| Intersection ID: 31122 | Main Street: MILLSTREAM_RIDGE_DR | Cross Street: N/A       | Location:              | NE                    |
| ADA ID: 946B1D07E3E6   | Ramp Type: BlendTrans1           | Initial Pass/Fail: Fail | Overall Compliance: No | Severity Score: 33.75 |

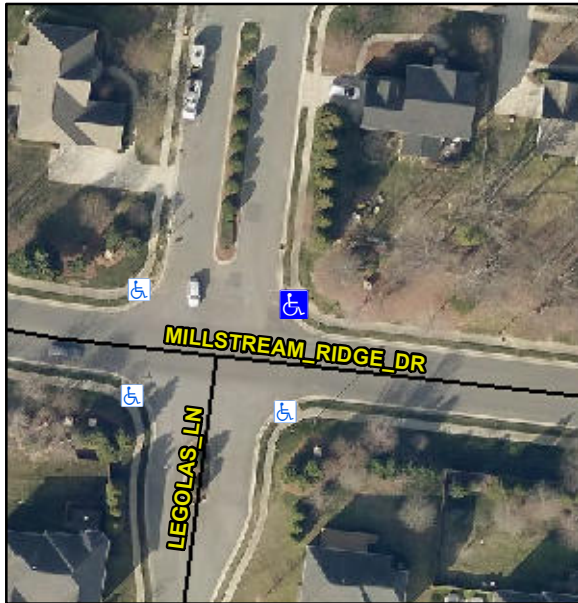
**Not Found, R304.5.1, R304.5.3**

| Compliance | Description           | Data | Compliance | Description                 | Data |
|------------|-----------------------|------|------------|-----------------------------|------|
| No         | Ramp Width (in)       | 42.0 | No         | BlendTrans XSlope (%)       | 10.7 |

**Remove & Replace Curb Ramp With Two New Directional Ramps or Equivalent.**
